TITLE SWA15A SWIVEL	
DWG NO. SWA15A	REV 1
MAT'L UNLESS OTHERWISE SPECIFIED DIMENSIONS ARE IN INCHES .XXX ± .005 FRACTIONS ± 1/8 .XX ± .01 ANGLES ± .5° .X ± .1	DRAWN BY: GILBERT APPROVED TREAT FINISH SPEC USED ON MODEL
1. BREAK ALL SHARP EDGES .015 x 45° OR .015R 2. DIMENSIONAL LIMITS APPLY AFTER PLATING	
SCALE 1:4	DATE 11/14/2012 SHEET 1 OF 2

WORK ORDER NON-CONFORMANCE / ROUTE UPDATE

Under Review Notification

Product Name: Swivel Hooks

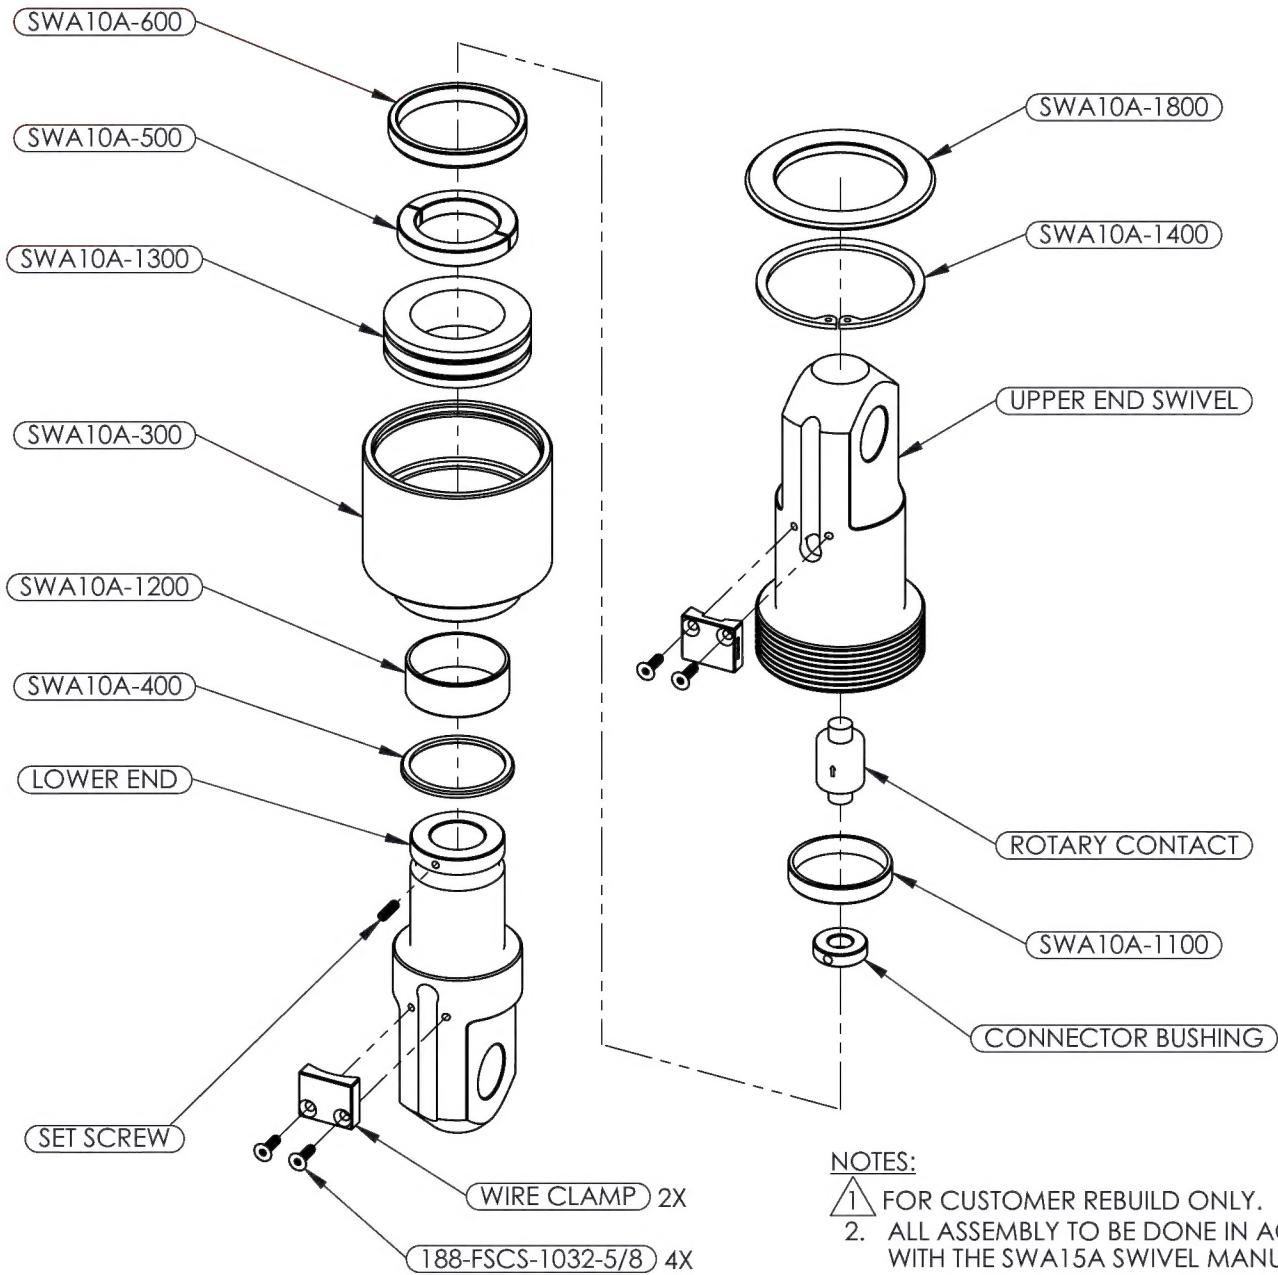
REVISIONS					
REV	ECR	DESCRIPTION	DATE	INITIAL	APPROVED
A		REPLACED ID DECAL 600.1311 WITH LASER ETCH	5/14/2013	JAG	
1	15-0163	UPDATED TO NEW DRAFTING STANDARDS. SWA6A-1900 CH'D QTY'S: -4 ASSY WAS 8 IS 4. -6 ASSY WAS 12 IS 8. -8 ASSY WAS 16 IS 12. EL314-SJTOW CH'D QTY'S: -2 &-3 ASSY WAS 6 IS 1; ADDED 6 FT TO B/O. EL414-ARTIC CH'D QTY: -4 ASSY WAS 6 IS 1; ADDED 6 FT TO B/O. EL616-ARTIC CH'D QTY: -6 ASSY WAS 6 IS 1; ADDED 6 FT TO B/O. EL816-ARTIC CH'D QTY: -8 ASSY WAS 6 IS 1; ADDED 6 FT TO B/O. SWA6A-200 ADDED TO BOM: ASSY -4, -6, &-8 QTY 4. 188-FSCS-1032-1/2 DELETED. 188-FSCS-1032-5/8 ADDED TO BOM. 188-FPSS-1032-1/2 CH'D QTY: -8 ASSY WAS 1 IS 0. 188-FPSS-1032-3/8 ADDED TO BOM. ADDED REBUILD NOTES. ADDED ENGRAVING NOTES.	7/9/2015	DPD	JAG

UNDER REVIEW
URF19-830

Electrical wire does not fit in hole and slot

No heat shrink call on the drawing

Electrical plugs are called in the BOM but are not required

Electrical wire need to be updated to have flexible wire type

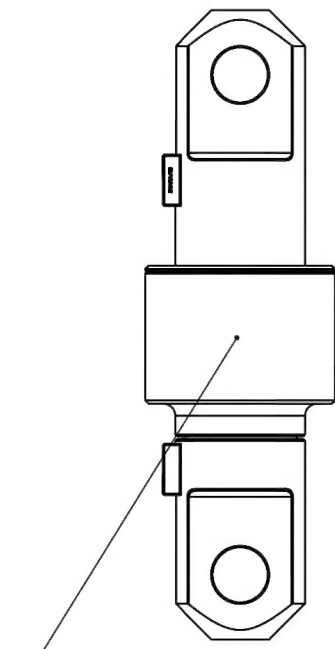
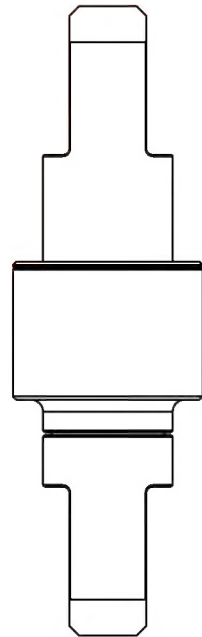
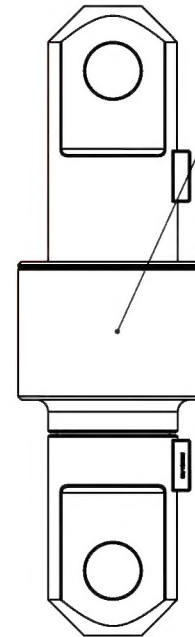
SEE ATTACHED DEVIATION

The electrical wires listed under "Acceptable Alternate Wire" on the attached sheet are acceptable to use in place of the "Drawing Specified Wire"		This deviation is acceptable. No change to fit form or function. The job route must specify the wire that is called out on the drawing The inventory P/N must reflect the same P/N that was received from a vendor		Lead hand / Supervisor
				QC / QA Coordinator
Root Cause		FAULT CATEGORY		
<div style="display: flex; flex-direction: column;"> <div>Operator <input type="checkbox"/></div> <div>Manufacturing Process <input type="checkbox"/></div> <div>Equip/Tooling <input type="checkbox"/></div> <div>Handling/Presservation <input type="checkbox"/></div> <div>Material <input type="checkbox"/></div> <div>Product Improvement <input checked="" type="checkbox"/></div> <div>Process Improvement <input type="checkbox"/></div> <div>Human Factors <input type="checkbox"/></div> </div>		<div style="display: flex; flex-wrap: wrap;"> <div style="width: 50%;"> <input type="checkbox"/> Pressure/Forced <input type="checkbox"/> Bending <input type="checkbox"/> Crushing <input type="checkbox"/> Cracks <input type="checkbox"/> Crimp/Kink/Ripple/Wave/Twist <input type="checkbox"/> Marks/Chatter <input type="checkbox"/> Mislabeled </div> <div style="width: 50%;"> <input type="checkbox"/> Contamination <input type="checkbox"/> Misaligned/off center <input type="checkbox"/> BOM/Route <input type="checkbox"/> Broken/Damage/Defect <input type="checkbox"/> Incomplete/Unclear Instructions <input type="checkbox"/> Drill Holes <input type="checkbox"/> Fit/Function </div> <div style="width: 50%;"> <input type="checkbox"/> Power Loss/Surge <input type="checkbox"/> Folio/Program <input type="checkbox"/> Grain Direction <input type="checkbox"/> Weld <input type="checkbox"/> Wrong Stock Pulled <input type="checkbox"/> Out of Sequence <input type="checkbox"/> Off-set/Set-up </div> <div style="width: 50%;"> <input type="checkbox"/> Positioned Wrong <input type="checkbox"/> Outside Tolerance <input type="checkbox"/> Drawing <input type="checkbox"/> Finish <input type="checkbox"/> Part Lost/Missing <input type="checkbox"/> Misread </div> </div>

P/N	Revision	Drawing Specified Wire	Acceptable Alternate Wire
C2	2	MIL-C-27500 11-14416	N/A
C3	2	MIL-C-27500 11-14417	N/A
C10	3	3/14 SJTOW	Texcan 01121-734A5 or 01004-08-047
C15	2	3/14 SJTOW	Texcan 01121-734A5 or 01004-08-047
C20	C	3/14 SJTOW	Texcan 01121-734A5 or 01004-08-047
C45	C	3/14 SJTOW	Texcan 01121-734A5 or 01004-08-047
C60	C	3/14 SJTOW	Texcan 01121-734A5 or 01004-08-047
C250	C	3/14 SJTOW	Texcan 01121-734A5 or 01004-08-047
SWA3-2	3	3/14 SJTOW	Texcan 01121-734A5 or 01004-08-047
SWA3-3	3	3/14 SJTOW	Texcan 01121-734A5 or 01004-08-047
SWA3-4	3	EL 414-ARTIC 4/14	Texcan 01121-744A5
SWA6A-2	E	Texcan 01121-724AM	N/A
SWA6A-3	E	Texcan 01121-734A5 or 01004-08-047	N/A
SWA6A-4	E	Texcan 01121-744A5	N/A
SWA6A-6	E	Texcan 04121-764A5	N/A
SWA6A-8	E	Texcan 12701-08-014 or McMaster 7081K38	N/A
SWA10A-2	3	3/14 SJTOW	Texcan 01121-734A5 or 01004-08-047
SWA10A-3	3	3/14 SJTOW	Texcan 01121-734A5 or 01004-08-047
SWA10A-4	3	EL 414 ARTIC 4/14	Texcan 01121-744A5

SWA10A-6	3	EL 616 ARTIC	Texcan 04121-764A5
SWA10A-8	3	Polar Wire 30806	Texcan 12701-08-014 or McMaster 7081K38
SWA15A-2	1	3/14 SJTOW	Texcan 01121-734A5 or 01004-08-047
SWA15A-3	1	3/14 SJTOW	Texcan 01121-734A5 or 01004-08-047
SWA15A-4	1	EL 414 ARTIC 4/14	Texcan 01121-744A5
SWA15A-6	1	EL 616 ARTIC	Texcan 04121-764A5
SWA15A-8	1	EL 816 ARTIC	Texcan 12701-08-014 or McMaster 7081K38
SAW25A-2	1	3/14 SJTOW	Texcan 01121-734A5 or 01004-08-047
SAW25A-3	1	3/14 SJTOW	Texcan 01121-734A5 or 01004-08-047
SAW25A-4	1	EL 414 ARTIC 4/14	Texcan 01121-744A5
SAW25A-6	1	EL 616 ARTIC	Texcan 04121-764A5
SAW25A-8	1	EL 816 ARTIC	Texcan 12701-08-014 or McMaster 7081K38
